ADDENDUM NO. 2

RENOVATIONS TO MYRTLE BEACH BOARDWALK

Myrtle Beach, South Carolina
October 15, 2021

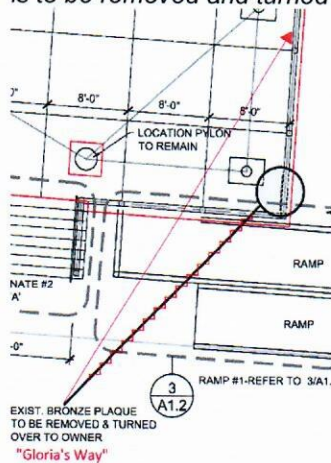
Q21. A3.3 RECESSED LIGHT FIXTURE DETAILS. DETAIL IS SHOWING A 32" SQUARE OF CONCRETE? THIS IS NOT THE CURRENT CONDITION. ARE THESE LIGHTS TO BE EMBEDDED IN CONCRETE OR IS DECKING CUT OUT AROUND THEM AND THE LIGHTS ARE ATTACHED TO WOOD STRUCTURE?

A21. Omit indication of concrete. New fixtures are to be installed in exact location as existing and connected to existing power. Fixtures are to be installed securely to structure.

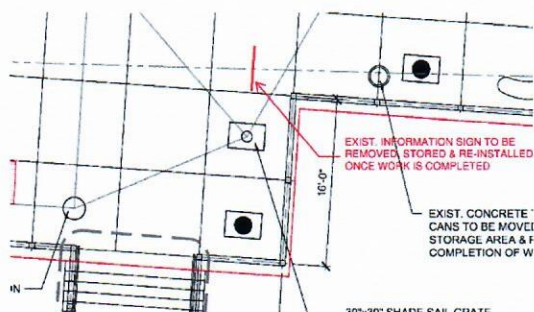
Q26. DETAIL 2/A1.0 ON THE LEFT SIDE BY THE STAIRS IS AN EXISTING INFORMATION SIGN THAT IS NOT SHOWN. SHOULD THIS BE REMOVED AND RE-INSTALLED?

A26. *Reference sketch below for location of existing information sign. Signage is to be removed, stored, and re-installed in same location upon completion of work in this area.*

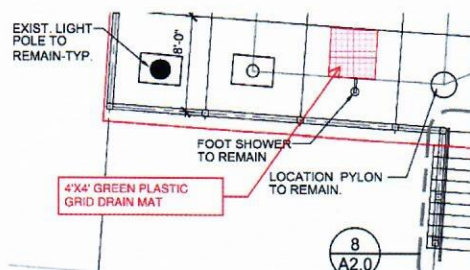
Q27. DETAIL 2/A1.0 ON THE LEFT SIDE OF THE PLAN SHOWS A FOOT SHOWER TO REMAIN. THERE IS CURRENTLY A GREEN PLASTIC GRATE 4'X4' INSTALLED IN THE DECKING IN FRONT OF THE SHOWER THAT IS NOT SHOWN ON THE PLAN. SHOULD THIS GRATE BE REINSTALLED IN THE NEW DECKING?

A27. *Reference sketch below indicating existing 4'x4' green plastic drain mat. Existing mat is to be removed, stored, and re-installed in same location upon completion of work in this area.*

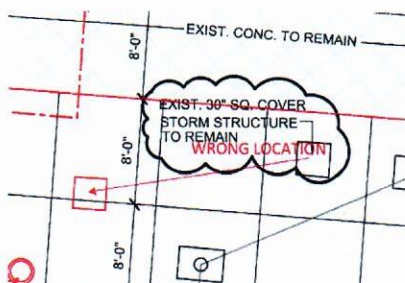
Q28. DETAIL 2/A1.0 ON THE LEFT SIDE OF THE PLAN SHOWS A 30" SQ. COVER TO REMAIN. THE PLAN SHOWS THIS IN AN INCORRECT LOCATION AND IS ACTUALLY ABOUT 16' TO THE LEFT OF WHERE SHOWN. IN GENERAL, AT THESE SQUARE COVERS, ARE WE SIMPLY REPLACING THE DECK BOARDS OVER EXISTING 30' SQUARE FRAME OR IS THERE SOMETHING MORE INVOLVED TO MAKING THESE SQUARE COVERS REMOVALBE?

A28. *Reference sketch below regarding approximate location of existing removable square covers. All of the existing removable covers are to be replaced with removable HDPE covers as shown on the attached Bulletin Drawing B3.*

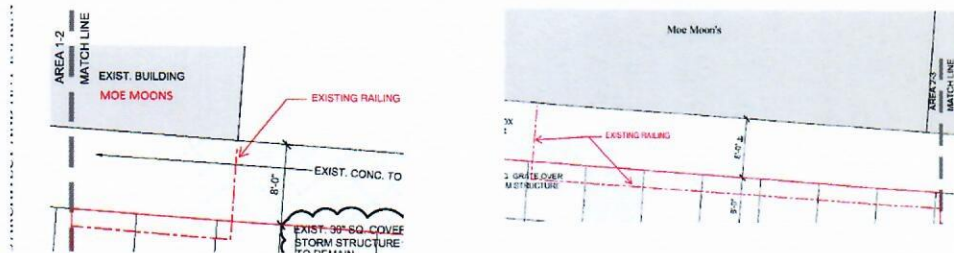
Q29. DETAIL 2/A1.0 AND DETAIL 3/A1.0 THERE IS CURRENTLY RAILING OUTSIDE OF MOE MOONS THAT IS NOT SHOWN ON OUR PLANS. IS THE GC TO REMOVE AND REPLACE THIS RAILING?

A29. *Clarification: ALL existing retail railings, furnishings, etc., are to be removed by the General Contractor prior to the start of work and replaced at the completion of the work in that area. Reference both sketches below.*

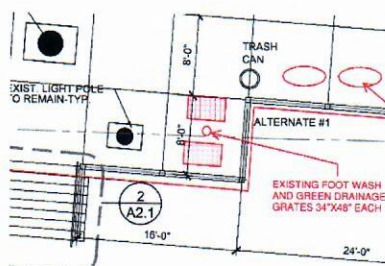
Q30. DETAIL 1/A1.1 DOES NOT SHOW THE EXISTING RAILING AND TABLE OUTSIDE SWEET TREATS STORE THAT IS ANCHORED TO THE WOOD DECKING. IS THE GC TO REMOVE AND REINSTALL OR WILL THE TENANT DO THAT?

A30. *Clarification: ALL existing retail railings, furnishings, etc., are to be removed by the General Contractor prior to the start of work and replaced at the completion of the work in that area.*

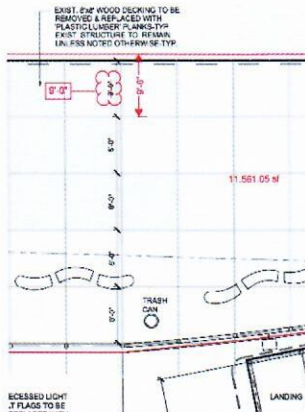
Q33. DETAIL 1/A1.1 THE DIMENSION STRING TO THE LEFT OF THE RAMP LANDING IS INCORRECT AT THE TOP OF THE DETAIL. PANELS ARE 9'-0", NOT 8'-0".

A33. *Reference sketch below. Omit reference of 8'-0" dimension for the top grid section and replace with the dimension of 9'-0".*

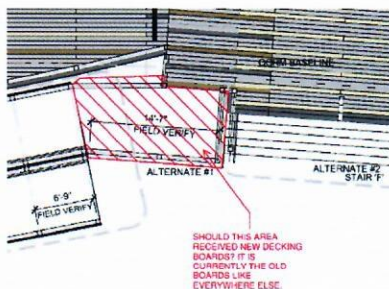
Q34. DETAIL 2/A1.4. SHOULD THE AREA AT THE TOP OF THE RAMP RECEIVED NEW DECK BOARDS? IT CURRENTLY HAS THE OLD DECK BOARDS INSTALLED.

A34. *Reference sketch below: cross-hatched area is to have existing wood planking removed and replaced with 4x6x16' HDPE molded plastic lumber planks with additional 2x12 PT wood support. Decking color is to be Color 1-Gray (lite) with the outer edge plank being one DARK GRAY HDPE board.*

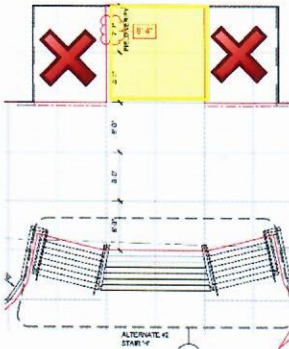
Q36. DETAIL 1/A1.2 THE DECK AREA ACROSS FROM STAIR 'H' IS NOT DRAWN 'AS IS'. ARE WE TO REPLACE WHAT DECKING IS CURRENTLY INSTALLED OR ARE WE TO EXPAND THIS AREA?

A36. *Reference sketch below: Omit the two 'X' areas. Omit reference to the dimension 7'-7" and replace with dimension 8'-0". The existing area (highlighted) includes the center portion of 16'x16'-4" only. The existing wood decking in the highlighted area is to be removed and replaced with 4x6x16' HDPE molded plastic lumber planks with additional 2x12 PT wood support.*

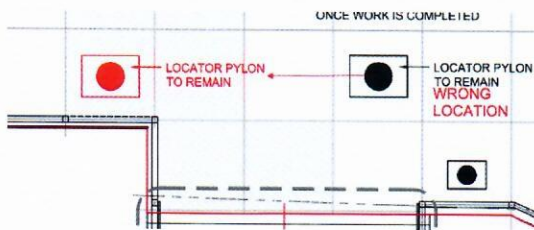
Q37. DETAIL 2/A1.2 THE LOCATOR PYLON IS NOT SHOWN IN THE CORRECT LOCATION.

A37. *Omit location of Locator Pylon (in black). Add location of Locator Pylon (in red) as indicated on the sketch below.*

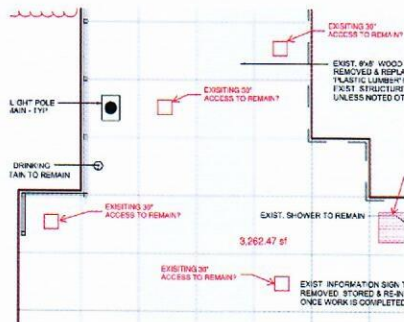
Q40. DETAIL 2/A1.2 PLAN DOES NOT SHOW FOUR 30" EXISTING ACCESS PANELS. ARE THESE TO REMAIN?

A40. *The existing 30' access panels as shown below are to remain. Existing removable panels are to be removed and replaced with new access panels as shown on the attached Bulleting Drawing B3.*

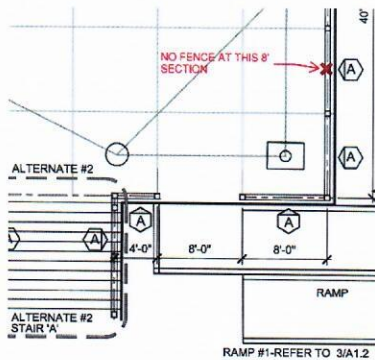
Q41. DETAIL 9/A2.0 ON THE FAR RIGHT SHOWS AN EXISTING RAILING AT THE BEGINNING OF A WALKWAY, THIS SECTION DOES NOT EXIST. ARE WE TO INSTALL A NEW FENCE SECTION AT THIS LOCATION?

A41. *Reference 9/A2.0; omit 8'-0" section of railing as indicated on the above sketch. There is no existing railing in this location and no new railing is to be added.*

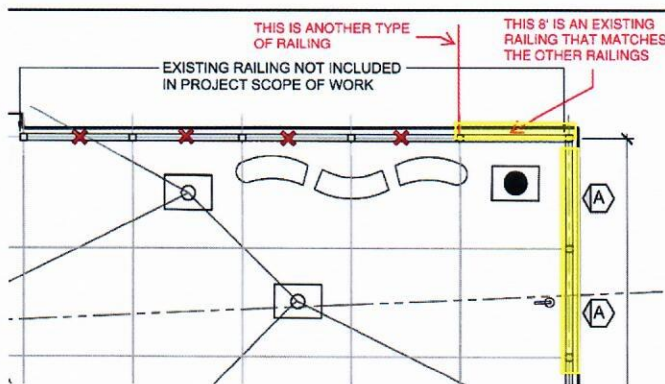
Q42. DETAIL 9/A2.0 ON THE RIGHT TOP OF DETAIL SHOWS 40' OF EXISTING RAILING NOT INCLUDED IN PROJECT SCOPE OF WORK. 32' OF THIS FENCE SHOWN DOES NOT EXIST AT THIS TIME BUT THE RIGHT SIDE 8' RAILING DOES EXIST AND MATCHES THE OTHER RAILINGS IN ALTERNATE #1. SHOULD THIS 8' SECTION BE INCLUDED AS PART OF ALTERNATE #1? THEN THERE IS ANOTHER RAILING COMING OFF THIS EXISTING RAILING THAT IS A DIFFERENT TYPE. ARE WE TO REMOVE AND REINSTALL THAT EXISTING RAILING OR INCLUDE IT WITH ALTERNATE #1?

A42. Refer to sketch below: omit indication of 32' of existing railing, this railing does not exist. The 8' existing railing indicated (highlighted) is to be replaced as part of Alternate #1.

2 RAILING PLAN - AREA 4 - ALTERNATE #1
A2.1 SCALE: 1/8"=1'-0"

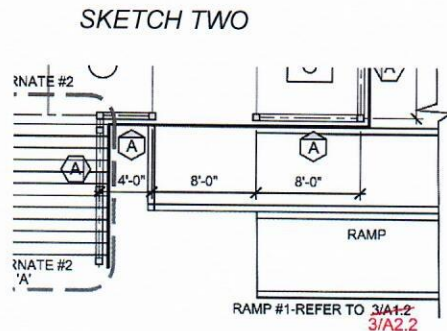
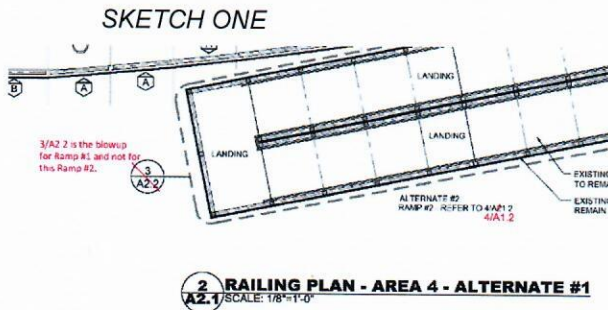
Q45. DETAIL 2/A2.1 SHOWS RAMP #2 IN AREA 4 WITH A CALLOUT OF 3/A2.2. DETAIL 3/A2.2 IS AREA 1 RAMP #1. SHOULD DETAIL 9/A2.0 RAMP #1 REFER TO DETAIL 3/A2.2 INSTEAD? IF THAT IS TRUE THEN IS THERE A RAILING DETAIL FOR RAMP #2 SHOWN ON 2/A2.1 WE DON'T SEEM TO HAVE A DETAIL FOR RAMP #2 AND WHAT TYPE OF RAILINGS ARE REQUIRED. SHOULD WE ASSUME ALL TYPE "A" SIMILAR TO RAMP #1 SHOWN ON A2.2?

A45. SKETCH ONE: Refer to Sheet A2.1, 2/A2.1 Railing Plan Area 4 – Alternate #1; omit reference 'bubble' 3/A2.2 and replace with 1/A2.3. Omit reference 4/A21.2 and replace with 4/A1.2, 1/A2.3, 2/A2.3 and 3/A2.3.

SKETCH TWO: Refer to Sheet A2.0, 9/A2.0 Railing Plan Area 1 – Alternate #1; omit reference to 3/A1.2 at ramp #1 and add 3/A2.2, 4/A2.2 and 5/A2.2.

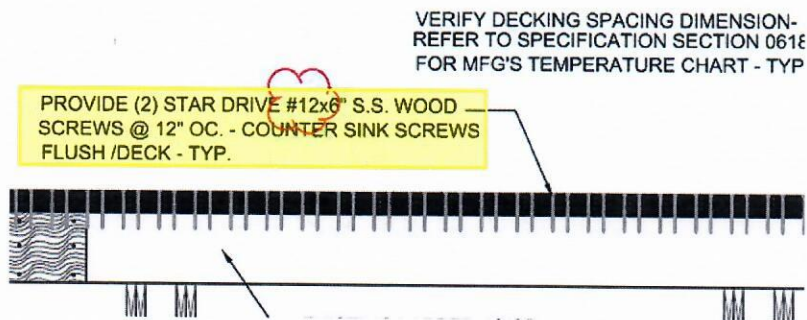
Q48. ALTERNATE #2 STAIR ELEVATIONS 7/A2.0 AND SECTION 8/A2.0 SHOW ALL MOLDED HDPE LUMBER FOR THE TOP RAIL, THE BALUSTER BRACES, THE 2X BALUSTERS AND THE BOTTOM RAIL. THE HANDRAILS ARE CALLED OUT TO BE P.T. WOOD. PLEASE CONFIRM THAT THE HANDRAIL SHOULD BE P.T. WOOD AND NOT MOLDED LUMBER.

A48. All railing components being replaced are to be HDPE molded lumber. The ADA handrail and blocking shown at ramps and stairs as part of Alternate #2 is pressure treated wood.

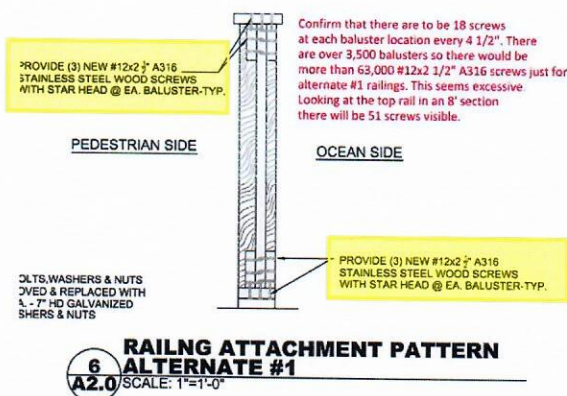
Q51. PLEASE CONFIRM THAT DETAIL 6/A2.0 RAILING ATTACHMENT PATTERN, THAT THERE WILL BE 18 SCREWS AT EACH BALUSTER LOCATION EVERY 4 1/2". THIS SEEMS EXCESSIVE.

A51. Omit highlighted notes below and replace with the following note: Provide (2) new #12x2 1/2" A316 Stainless Steel wood screws with star head 16" o.c. at each baluster-typ.

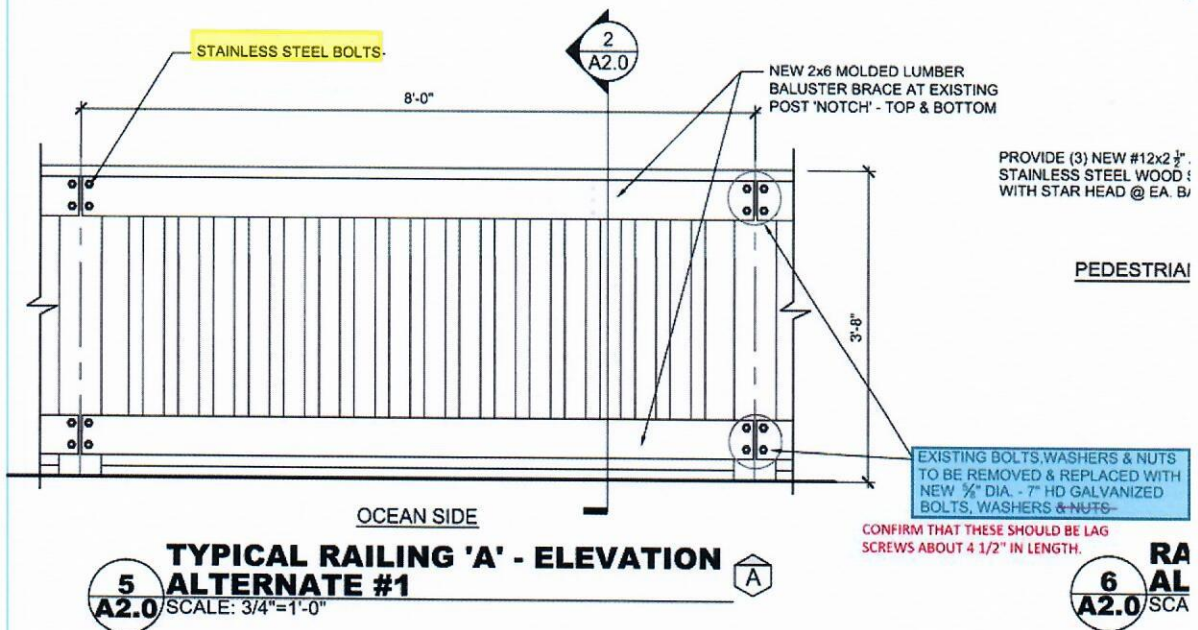
Q53. DETAIL 5/A2.0 TYPICAL RAILING 'A' SHOWS BOTH STAINLESS STEEL AND HD GALVANIZED BOLTS. WHICH IS CORRECT? SAME DETAIL CALLS FOR REPLACEMENT BOLTS TO BE 5/8" DIA. - 7" BOLTS, WASHERS & NUTS. THE EXISTING BOLTS THAT ARE BEING REPLACED ARE LAG SCREWS PROBABLY 4 1/2" LONG WITH A WASHER. PLEASE CONFIRM IF WE ARE TO USE 7" THRU BOLTS OR 4 1/2" LAG SCREWS.

A53. Reference sketch below (yellow highlight) and Detail 5/A2.0: All bolts are to be Stainless Steel. Reference sketch below (light blue highlight): Omit highlighted note and replace with the following note: Existing bolts, washers and nuts to be removed and replaced with new 5/8"-4-1/2" in length A316 Stainless Steel lag screws.

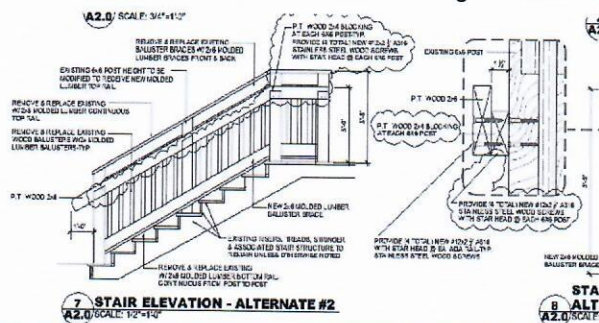
Q54. DETAIL 8/A2.0 BLOWUP OF HANDRAIL ATTACHMENT. PLEASE CONFIRM IF THIS NOTE SHOULD READ (8 TOTAL) SCREWS. 4 TO ATTACH THE 2X4 TO THE POST PLUS 4 TO ATTACH THE 2X6 HANDRAIL TO THE 2X4. ALSO, SHOULD THE 2X4 BE CONTINUOUS BEHIND THE HANDRAIL OR JUST A 2X4 BLOCK SPACER AT EACH POST?

A54. Reference clouded areas. The PT blocking behind the 2x6 PT handrail is to be attached to the existing 6x6 post with fasteners as noted in detail 7/2.0 and enlarge detail. The 2x4 is NOT continued from post to post.

ADDENDUM NO 2 DRAWING.: B1

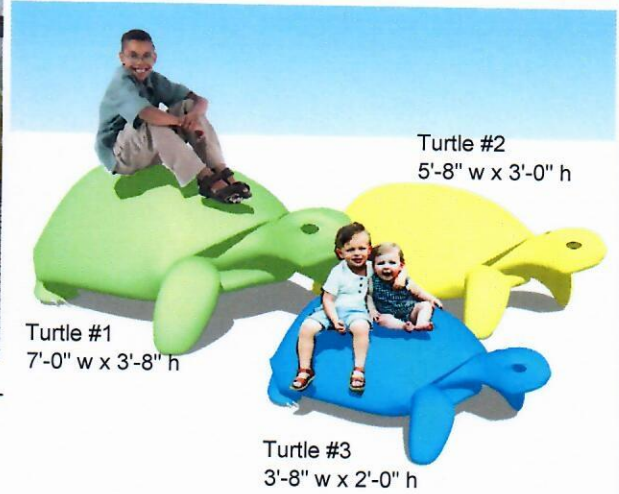
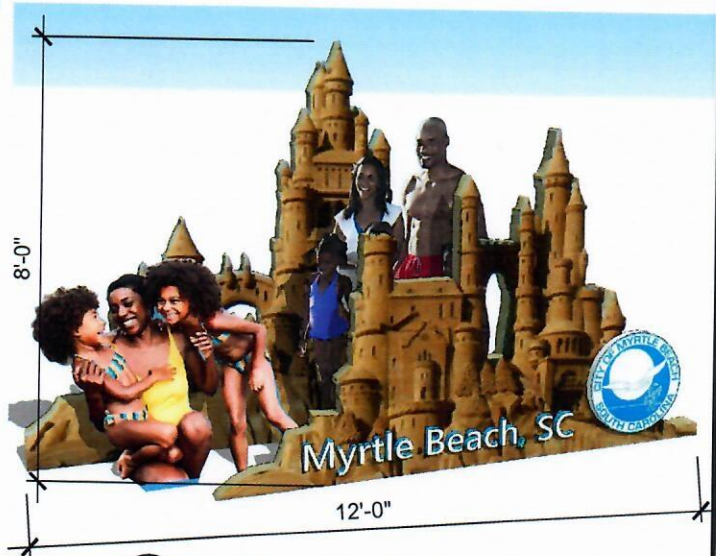
Q49. ALTERNATE #3 ON A1.5 SAYS THE SCALE IS 1/8" = 1'-0", THIS MAKES THE PHOTO-OP FIGURES AROUND 50 FEET WIDE. PLEASE CONFIRM THE SCALE FOR THESE PHOTO OPS.

Q61. DO YOU HAVE A NEW IMAGE TO REPLACE THE SURFER?

A49. Reference A1.5 Alternate #3 Photo op figure; omit scale reference of 1/8" at 3, 4, 5, 6/A1.5. Refer to Bulletin Drawing B1 attached for Photo Op Figure dimensions.

A61. *Reference Sheet A1.4 – Omit Photo Op #4 – Alternate #3 and replace with Photo Op #4 Sandcastles shown in the attached Bulletin Drawing B1.*
